SERVICE LETTER

No. 665A

Piper Aircraft Corporation

Rotator Type Intake Valves -- reference Lycoming Service Instruction No. 1280A dated September 28, 1973, reproduced on reverse side.

Rotator Intake Valve Components

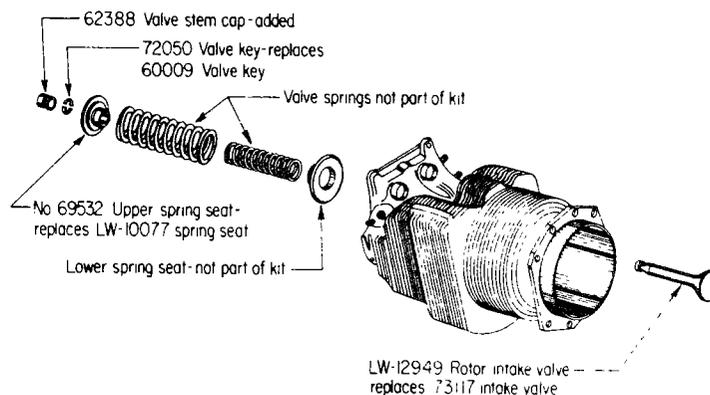
In order to improve valve seating and minimize compression loss at the intake valve seat, a new intake valve, incorporating a rotator cap is available for installation in applicable aircraft engines now in service. This rotator valve, LW-12949 and its associated parts replace the conventional intake valve, 73117 that has been used in these engines.

1 no. LW-12949	Intake Valve (replaces 73117 intake valve)
1 no. 69532	Upper Spring Seat (replaces LW-10077 spring seat)
2 no. 72050	Valve Key (replaces 60009 valve key)
1 no. 62388	Valve Stem Cap (added part)
